## Road Safety Audit

Title: **Stage 1 ROAD SAFETY AUDIT**

**Proposed Data Centre R409, Naas, Co. Kildare**

Report reference: **1918R01**

### 3.1 Problem

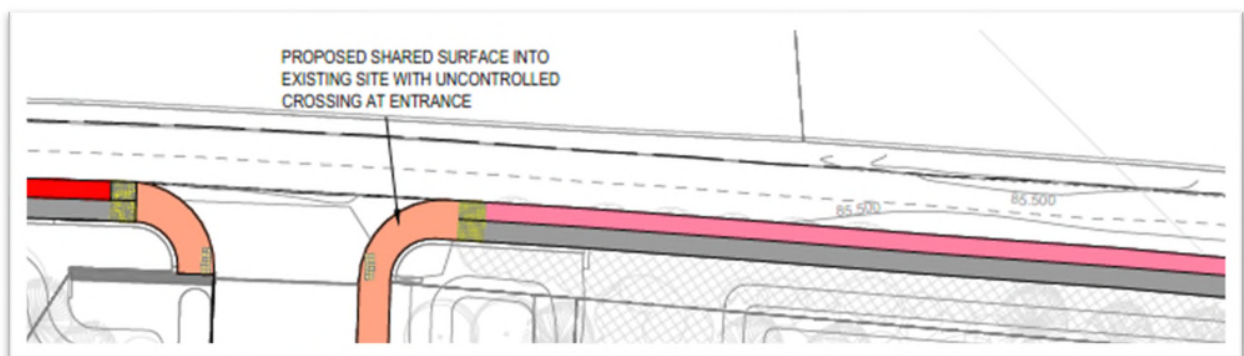
It is proposed to provide a cycle track to the proposed development and beyond in the northbound direction. It is not however proposed to provide cycling facilities for those returning from the development to Naas in the southbound direction. A lack of segregated facilities in the southbound direction will lead to less protection for cyclists from general traffic.

It is recommended that southbound facilities be provided.

3.1	YES	No	DOBA have discussed and agreed the extent of the required works to the R409 with K.C.C. Roads Dept. The works will be limited to the development side of the R409. These works will not prevent K.C.C. from carrying out additional upgrade works to the pedestrian and cycle infrastructure along the R409 in the future.	Yes

### 3.2 Problem

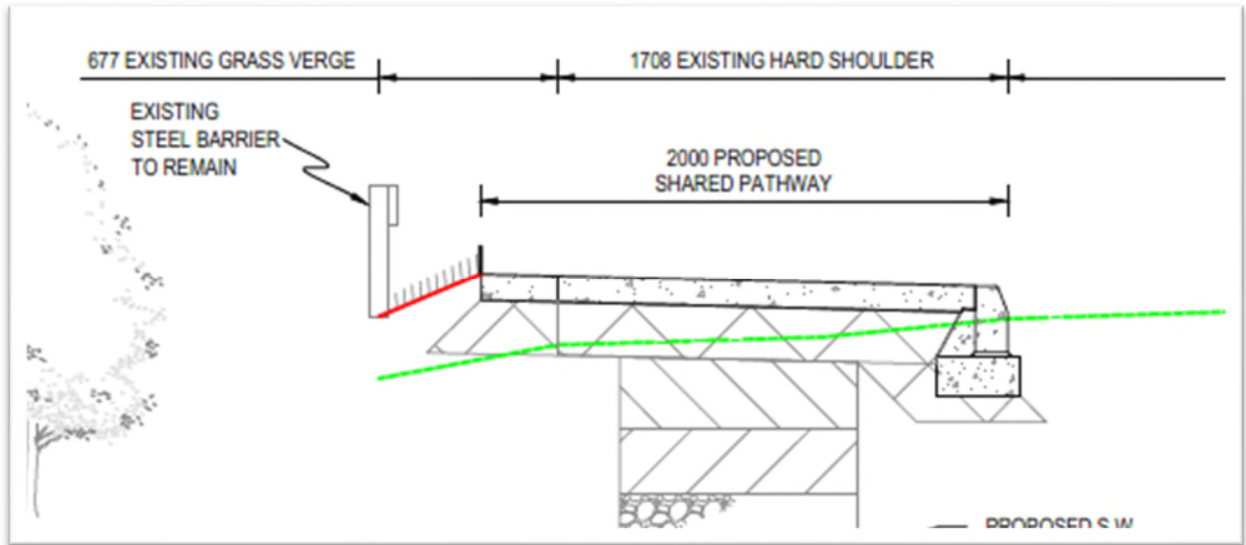
There are approach and departure safety barriers at the structure protecting errant vehicles from the high embankments and motorway below. With the provision of a kerbed edge and paved surface above the existing level the barriers may no longer contain errant vehicles if they are too low. It is also observed during the site visit that the safety barriers may not be EN1317 compliant.

It is recommended that the safety barrier be upgraded as necessary to ensure that errant vehicles will be contained.

3.2	YES	YES	The road barrier will be raised up to be in accordance with the requirements of TII	
3.3	YES	YES	The parapet railing will be raised, if necessary, in consultation with TII

### 3.4 Problem

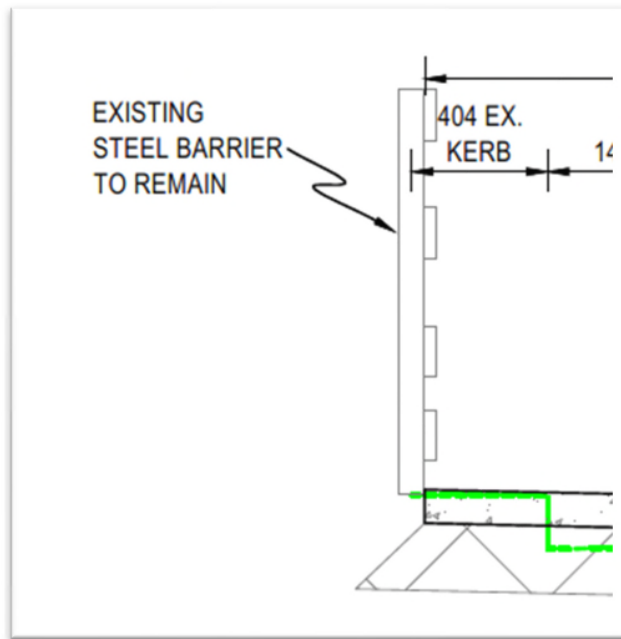
It is unclear if the existing parapet on the M7 overbridge will function as intended if struck by a HGV if there is no concrete upstand. A lack of containment could lead to vehicles descending onto the motorway below.

It is recommended that the adequacy of the parapet without a upstand be checked to ensure that it will contain errant vehicles as intended.

3.4	YES	YES	The parapet railing will be assessed to ensure its function is not degraded by the proposed works in consultation with TII.	
3.5	YES	NO	DOBA have discussed and agreed the provision and location of the bus stop with Kildare Co. Council. This work would also impact on 3 <sup>rd</sup> party land owners and is outside of the scope of the proposed project.	Yes

### 3.5 Problem

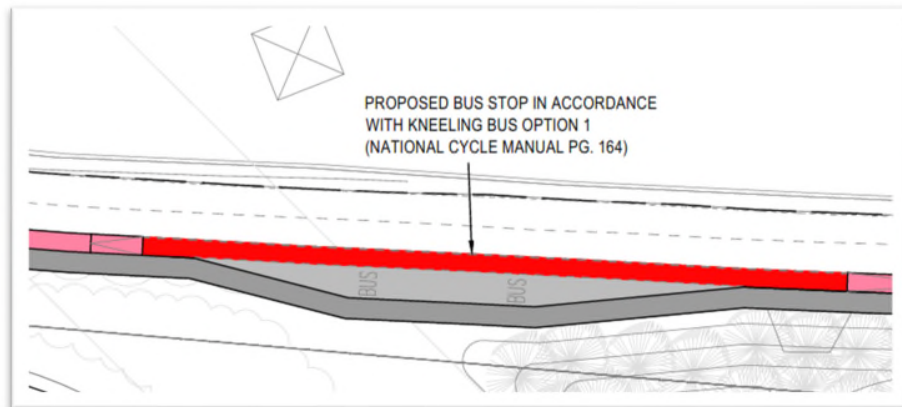
It is proposed to provide a bus layby that will presumably serve both the proposed development and the Oberstown Industrial Park. No provision has been made for crossing bus users or those getting the return bus to Naas. A lack of crossing facilities could lead to pedestrians stepping out from in front of or behind parked buses leading to collisions with through traffic.

It is recommended that a bus stop be provided on the opposite side of the R409 and that a crossing facility also be provided.

## 3.6 Problem

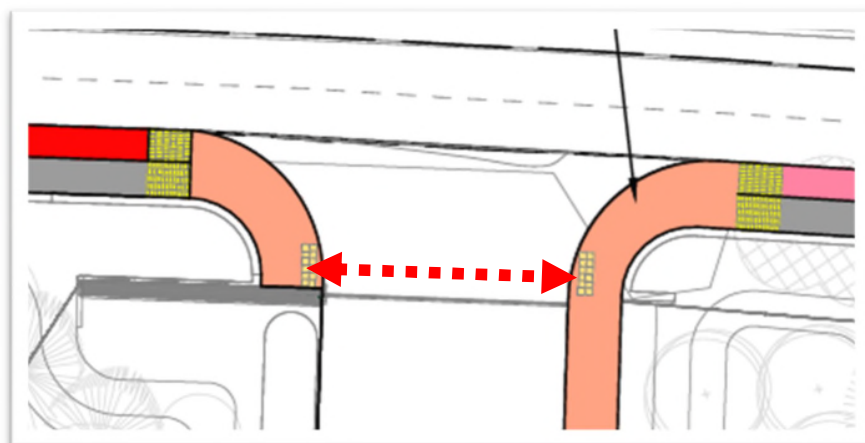
The crossing point at the proposed access junction for cyclists and pedestrians is set back from the through route, is narrow for both users and may be close to the gate which could obscure an exiting driver's visibility to those crossing vulnerable road users. This could lead to collisions between cyclists and pedestrians as they share space, collisions with exiting vehicles or lack of use of the cycle track as cyclists see the crossing as being too far off the desire line and opt to remain on the carriageway instead.

It is recommended that a wider crossing be provided closer to the desire line.

3.6	YES	YES	The crossing will be relocated closer to the R409 along the desire line for pedestrians and cyclists.	
3.7	NO	NO	A raised table will adversely impact on HGVs and other vehicles entering and exiting the site. It will require vehicles to slow to very low speeds in order to mount the table.	Yes

**3.7 Problem***LOCATION*

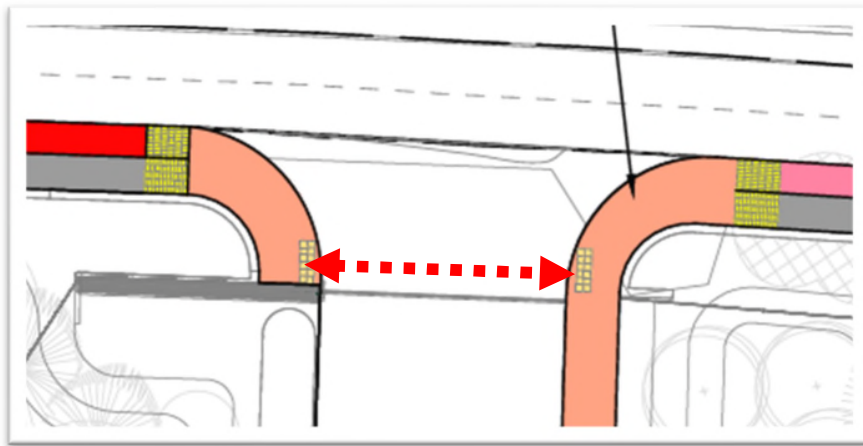
The main access junction has a wide cross sectional width due to the splitter island and need to cater for HGVs. This will lead to high turning speeds for smaller vehicles and thereby increase the risk of collisions with crossing pedestrians and cyclists.

It is recommended that a raised table be provided to cater for crossing pedestrians and cyclists.

This will cause potential queuing issues and static vehicles making left-in turns on the R409. It will also result in slow start-off speeds for HGVs and other vehicles existing the site onto the R409. There will be very low use of the footpath and cycle track to the west of the site access as the pathway is discontinued at the western extent of the site and therefore road crossings by vulnerable road users will be limited.	
3.8	YES	YES		
3.9	YES	YES

**3.8 Problem***LOCATION*

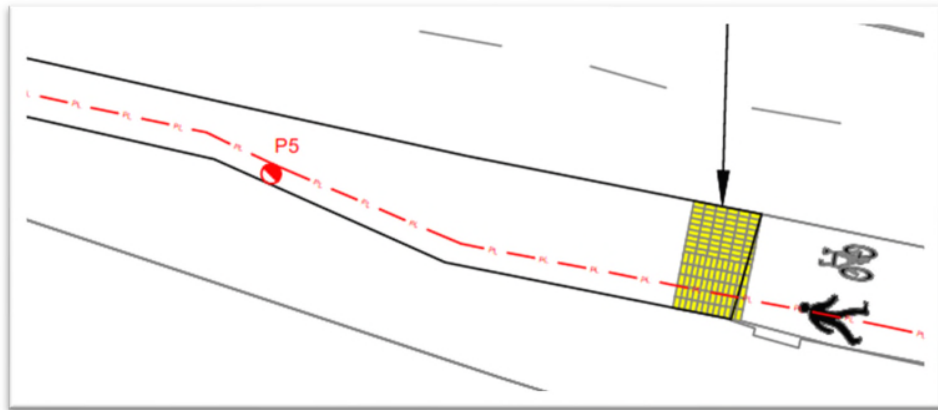
It is proposed to provide the public lighting columns within the new and existing footpaths. The columns could be hazards for pedestrians if they are looking down and are distracted and the columns also reduce the effective width of the footpath.

It is recommended that the columns be set back off the footpaths into the verge behind.

## 3.9 Problem

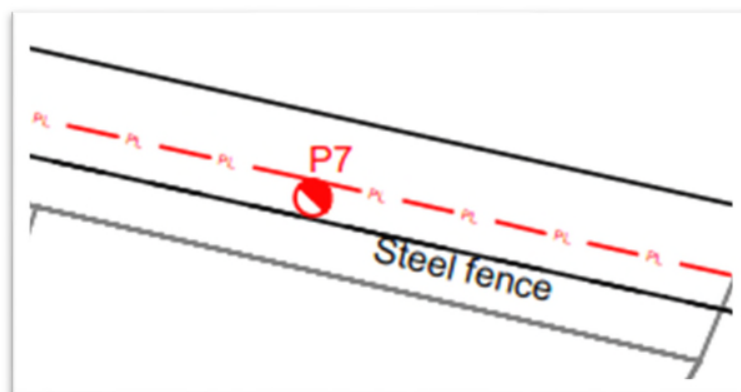
It is proposed to provide the public lighting columns in front of the safety barrier on the R409. Vehicles that collide with the barrier may be directed into the columns rather than be redirected into the carriageway resulting in more severe collisions.

It is recommended that the columns be provided to the rear of the safety barriers and at least the Working Width behind the barrier.
